# UNITED STATES PATENT AND TRADEMARK OFFICE

APPLICATION NO.	FILING DATE	FIRST NAMED INVENTOR	ATTORNEY DOCKET NO.	CONFIRMATION NO.
10/692,613	10/24/2003	Mark A. Francis	K-2043	8816

## Office Action Summary

## **DETAILED ACTION**

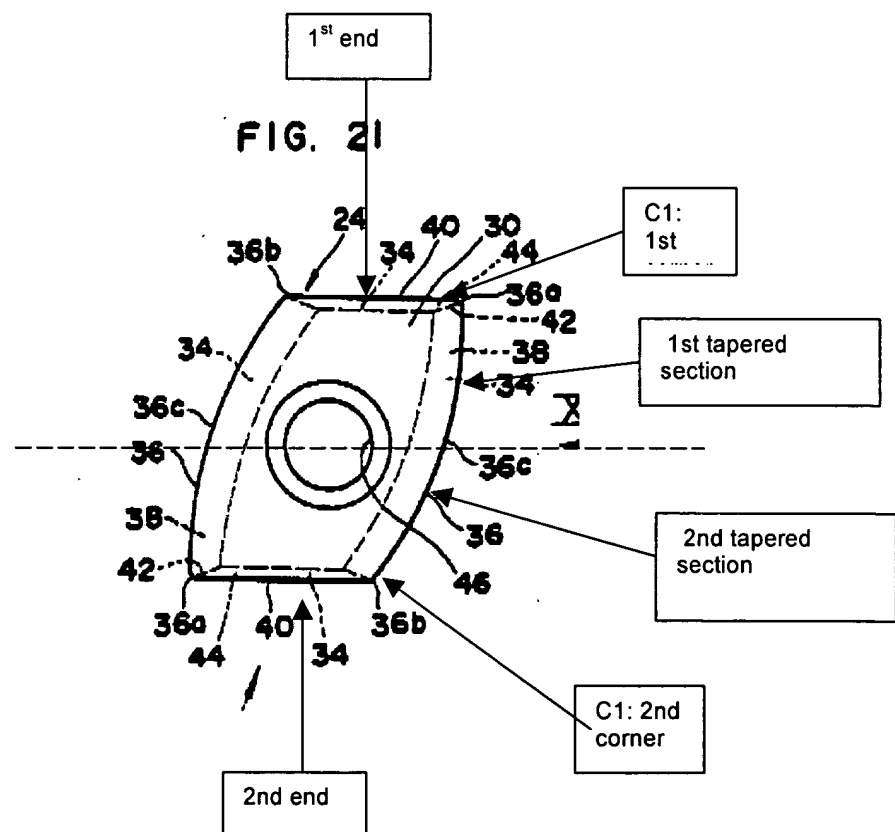
SHIMOMURA ET AL. teaches a rotary cutting tool (10c) including a body having a rotational central axis, plurality of adjacent flutes (first and second) (20c) formed in said body (12c) and including adjacent insert receiving pockets (22c) (first and second

insert receiving pockets) with inserts (24a) mounted in them ('383, figure 3 and Col. 8, lines 47-60). SHIMOMURA ET AL. also teaches each cutting insert (24a) having a first end, a second end, a centerline (CT) disposed midway between the first and second ends, a tapered cutting edge (36) spanning between the first and the second end, a first corner (c1) formed at the juncture of the tapered cutting edge and the first end and a second corner (c2) formed at the juncture of the tapered cutting edge and the second end (see figure below).

FIG. 35

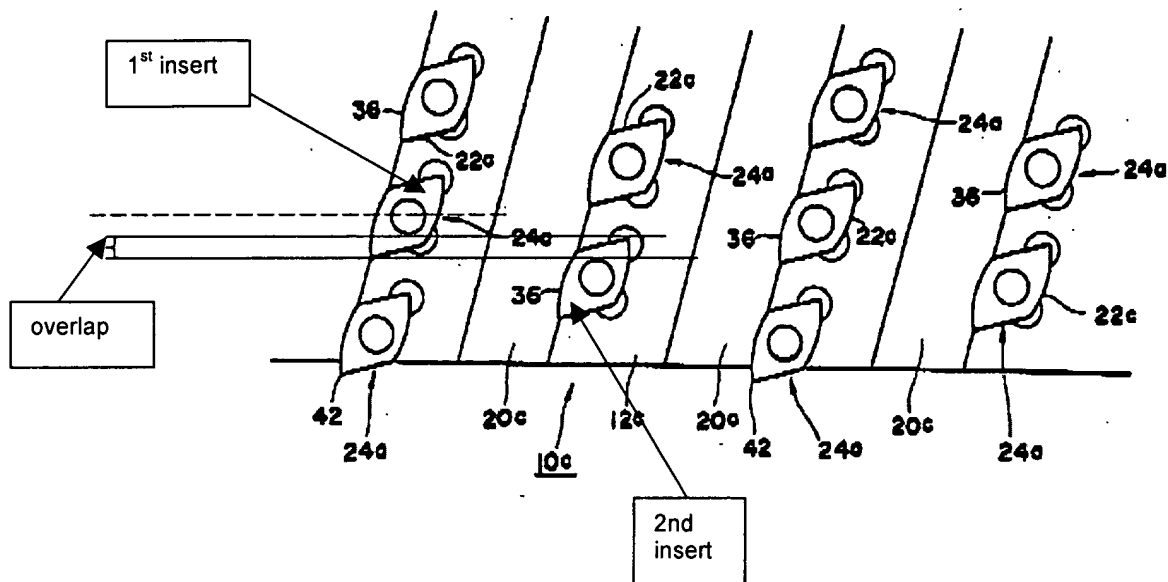
Regarding claims 18, 28 and 38, SHIMOMURA ET AL. discloses the centerline of the first insert and the end of the second insert overlapping (see figure below).

Regarding claims 20-23, 30-33, 40-42, SHIMOMURA ET AL. teaches in figure 35, cutting edges (36) parallel to each other. Additionally, the tapered cutting edge (36) of the insert is defined by a first and second tapered section, forming a convex curve configuration of a constant radius (see figure below). Regarding claims 24, 25, 34, 35, 43 and 44, although SHIMOMURA ET AL. is silent about the first and second flutes and insert receiving pockets being helically arranged, SHIMOMURA ET AL. teaches in figure 35, the cutting edge of each insert being axially spaced apart from the cutting edge of the next adjacent insert and the inserts in each flute are staggered such that two or more rows are necessary to produce one complete or "all effective" cutting edge therefore they are helically arranged. This insert/flute arrangement for a conventional helical mill is evidenced by DEROCHE ET AL. ('811, Col. 1, lines 14-15 and 18-23).

Regarding claims, 19, 29 and 39, SHIMOMURA ET AL. discloses the claimed invention, i.e. the first and second inserts overlapping (see figure below) except for the centerline of the first insert overlapping the first end of the second insert by more than half the
